Locations: 1728 Chapin

Subject: Root Street Conflict

Assignment: Arborist was asked to provide recommendations for the treatment subsequent to the removal of sidewalk, curb and street from around the tree.

Photo 1. Photo to the left below shows the root (Red Arrow) that is growing under the street. Cutting this root will compromise the tree stability beyond acceptable limits.

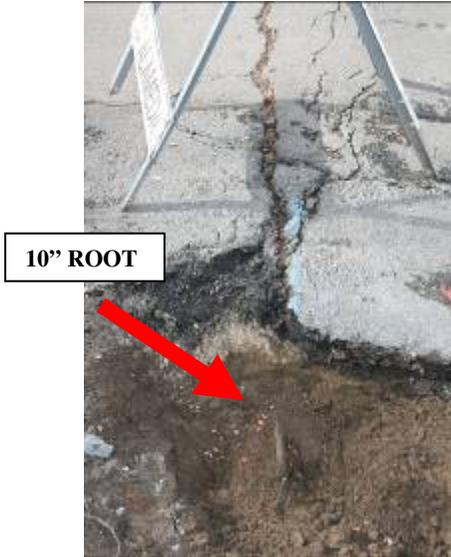
Photo 2. Photo above shows the uplifted street that extends well out to the center of the roadway. Only cutting the root will solve the problem.

It is recommended that this tree be removed and replaced prior to making street repairs.
